## SECTION 00 91 02

### ADDENDUM 2

Project  
**Lake Forest Library Dome Roof Replacement**  
360 Deerpath Road, Lake Forest, IL 60045

Figure 3. Access door from attic into laylight area.

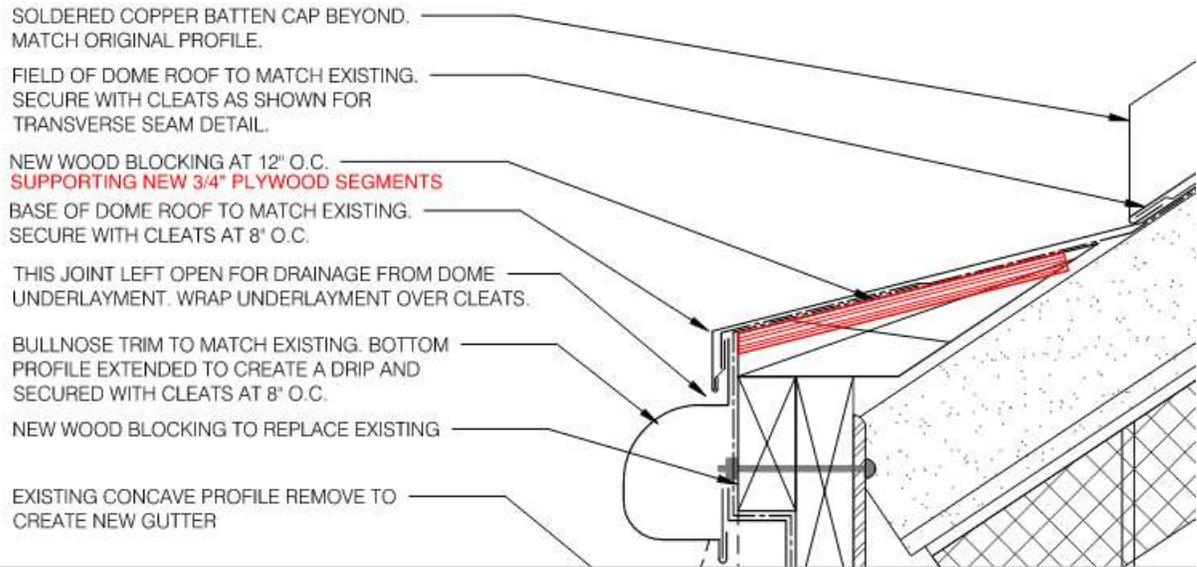
- A. Question: In reference to the note on sheet A202 which reads, "EXISTING PLASTER WALLS. PROTECT IN PLACE DURING THE PROJECT. PRIME AND PAINT WHITE," what means of access is available at the plaster cylinder for this work?
  - 1. Answer: There are existing metal brackets at the perimeter walls as well as the central hub of the laylight that are available to support lightweight planking or similar access inside the cylinder. The access door into the cylinder from the attic is relatively small, approximately 18 by 36 inches. Additional photographs follow.

+6Refer to detail 5/A501

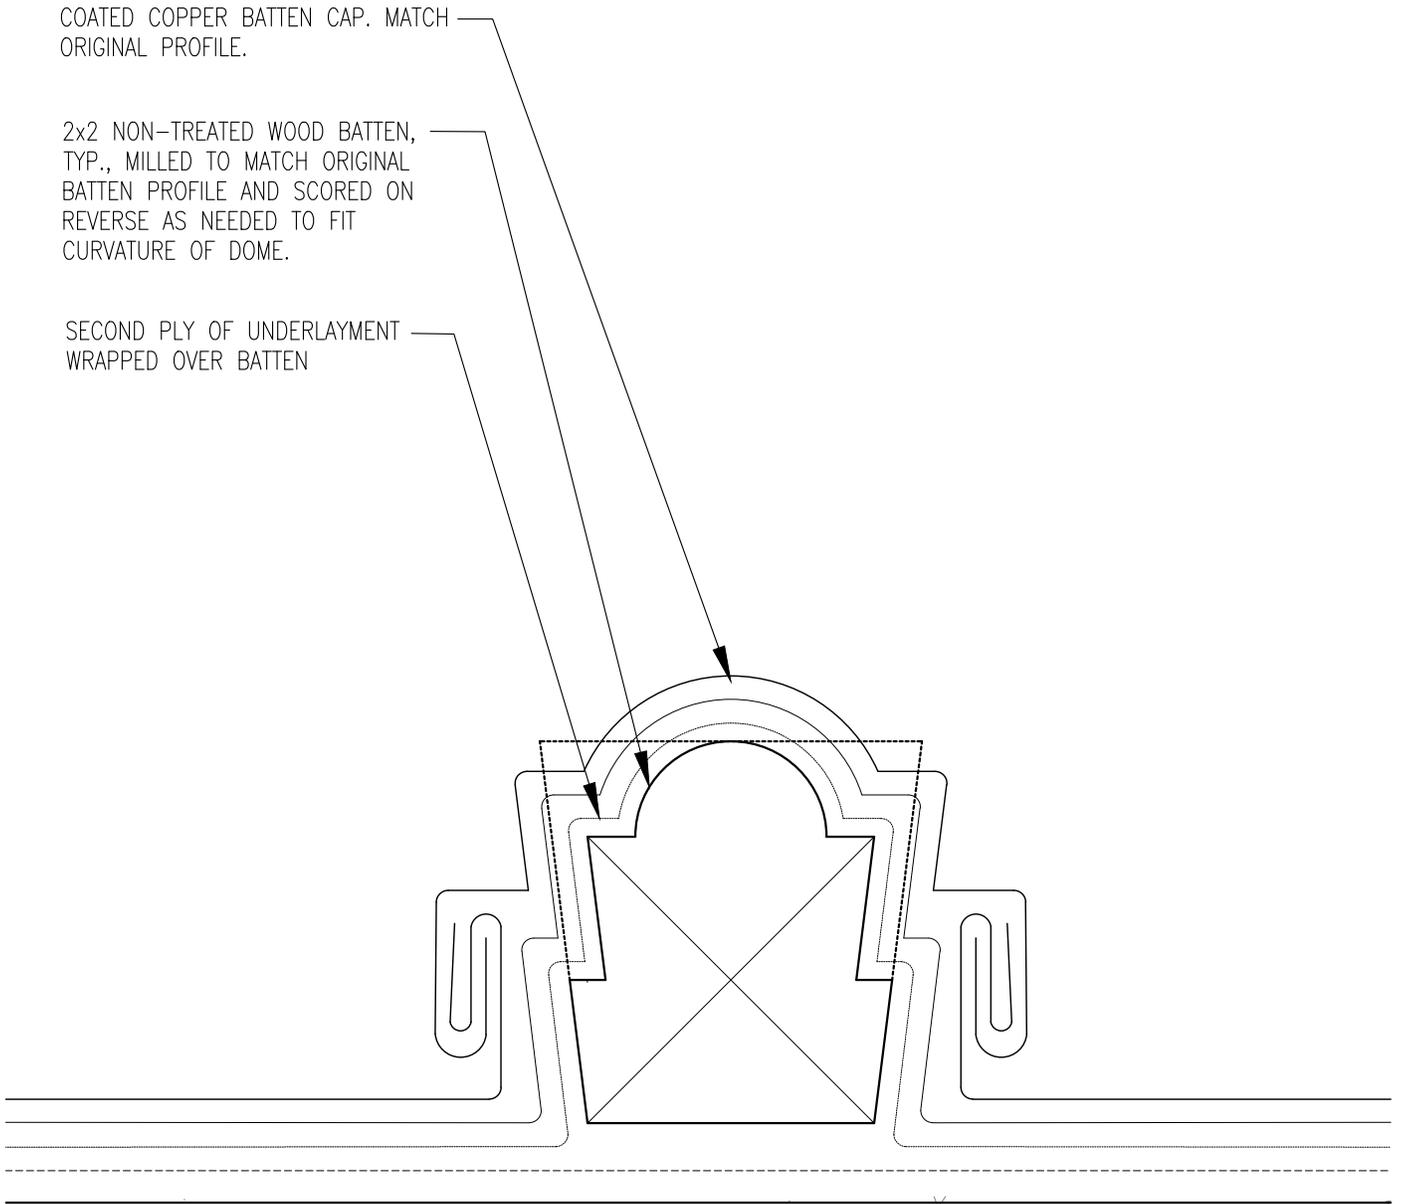
1. Answer: Batten caps should be lapped and soldered. See paragraph 3.3-G-5.
- V. Question: Regarding the New Gutter at Base of Dome, Detail 5/A501 – New wood blocking at 12”o.c. At the base of the dome roof there is wood blocking at 12” o.c. to be mitered at the proper angle for the apron flashing to transition from up under the end of the copper batten to over the edge of the wall above the new bullnose. Please confirm if plywood should be installed on top of the mitered wood blocking to provide continuous support?

1. Answer: Correct, please provide 3/4 inch plywood atop the blocking to provide support for the underlayment and metal roofing. See attached annotation to detail 5/A501.

**SK-1**

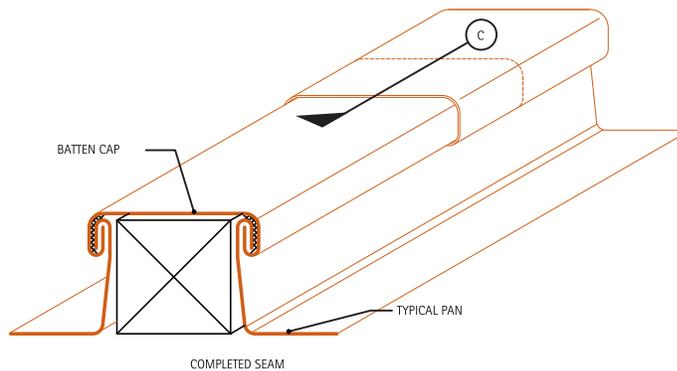
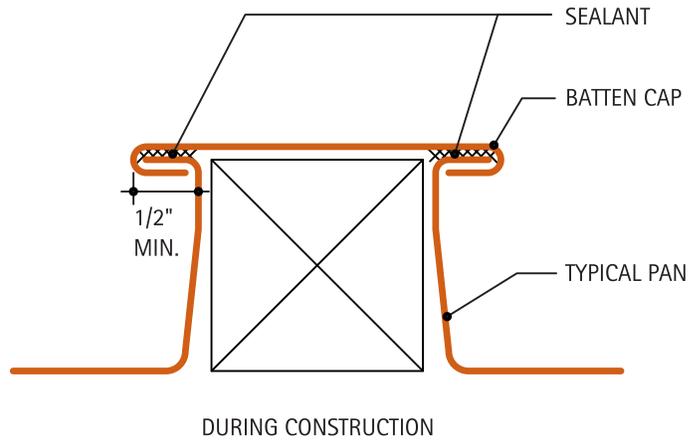
- B. Question: It is difficult to visualize the decorative profile of the batten covers from the photographs. Can detail 3/A501 be updated?
1. Answer: Refer to SK-1, depicting the typical batten geometry; exact dimensions to be verified in the field.

COATED COPPER BATTEN CAP. MATCH ORIGINAL PROFILE.

2x2 NON-TREATED WOOD BATTEN, TYP., MILLED TO MATCH ORIGINAL BATTEN PROFILE AND SCORED ON REVERSE AS NEEDED TO FIT CURVATURE OF DOME.

SECOND PLY OF UNDERLAYMENT WRAPPED OVER BATTEN

Ref. Detail 3/A501

### 8.1C. Batten Cap

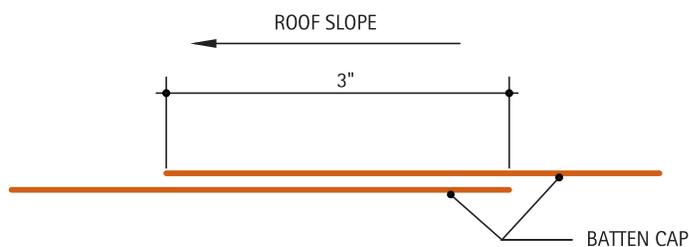
- U. Question: Regarding the Transverse Seam depicted in detail 2/A501 – Confirm that if any seams are required in the Batten Cap that they should be lapped a minimum of 3” per CDA Detail 8.1C?

Where batten caps join, a 3" lapped seam is required

### 8.3G. Alternate Cleat Types

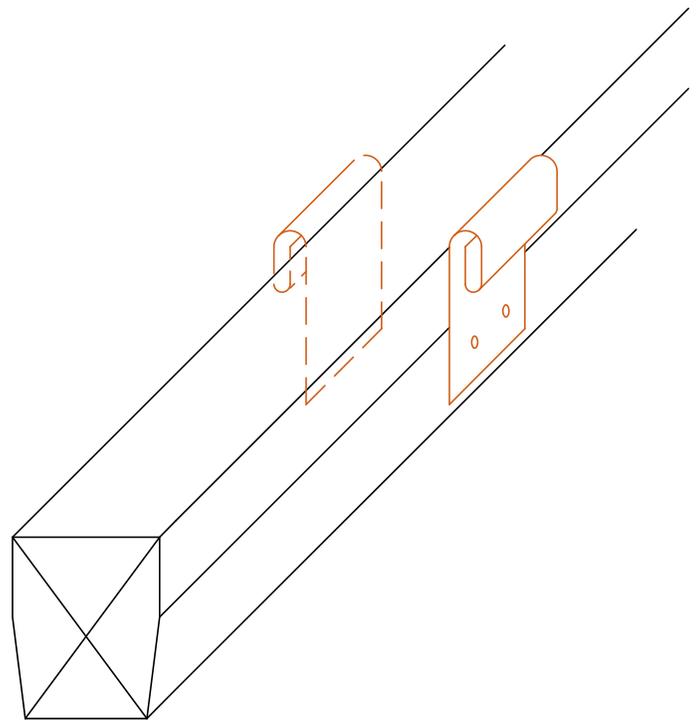
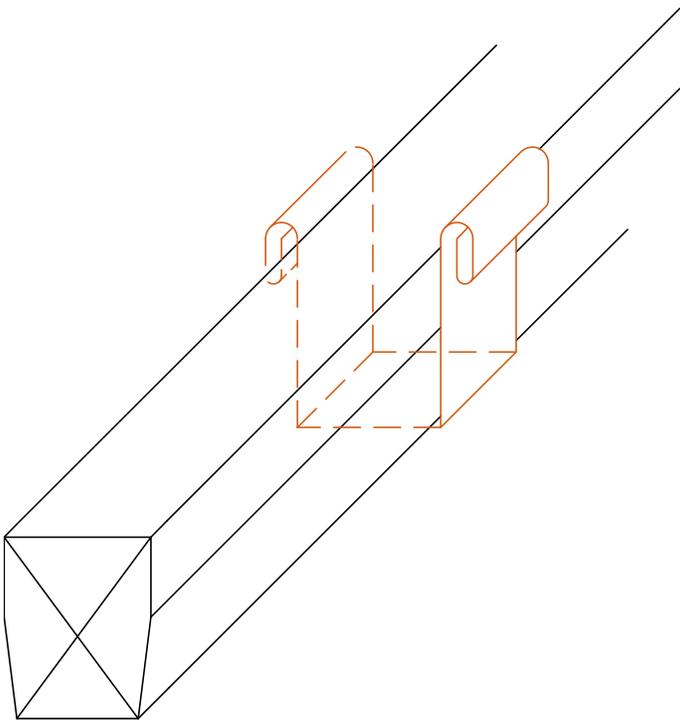
1. Answer: Yes, this is the correct understanding of the design intent. CDA detail 8.1B is attached for reference by all bidders.
- T. Question: Regarding the Transverse Seam depicted in detail 2/A501 – Confirm that in addition to the “CLEAT WITH UPTURNED LEG FASTENED TO BATTENS” there should also be cleats along the batten similar to CDA Detail 8.3G. Confirm these cleats should be at 12” o.c. and can be installed by either method shown on CDA Detail 8.3G

1. Answer: Yes, the batten cleats depicted in CDA detail 8.3G option 2 match the design intent for securing the panels to the batten strips. CDA detail 8.3G is attached for reference by all bidders.

These types of cleats may be used with batten seam roofs. The type shown on the left must be placed during batten installation. The type on the right is attached to the installed battens with copper nails before or after batten installation.

ROBERTSON DOUBLE GLAZED DOUBLE PITCH SKYLIGHT

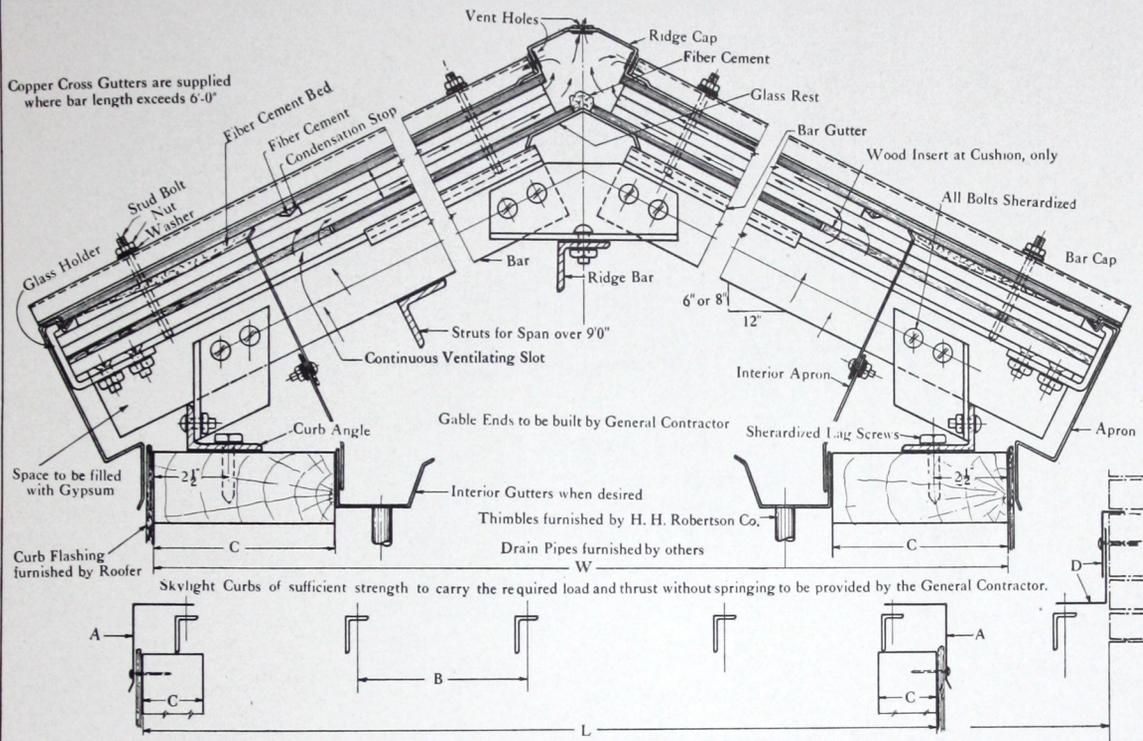
- H. Question: Regarding the skylight, is there any as-built information available as to the original manufacturer that can be provided? Is this a double glazed skylight?

1. Answer: The skylight is identified on the 1930 architectural drawings as a double-glazed skylight with internal gutters provided by the H. H. Robertson Company. The attached catalog cut sheet shows the type of system manufactured circa 1930 by the Robertson Company. This generally appears to be the type of skylight that is present on site. The skylight is double glazed, meaning two independent layers of single-pane wire glass are present (not IGUs).
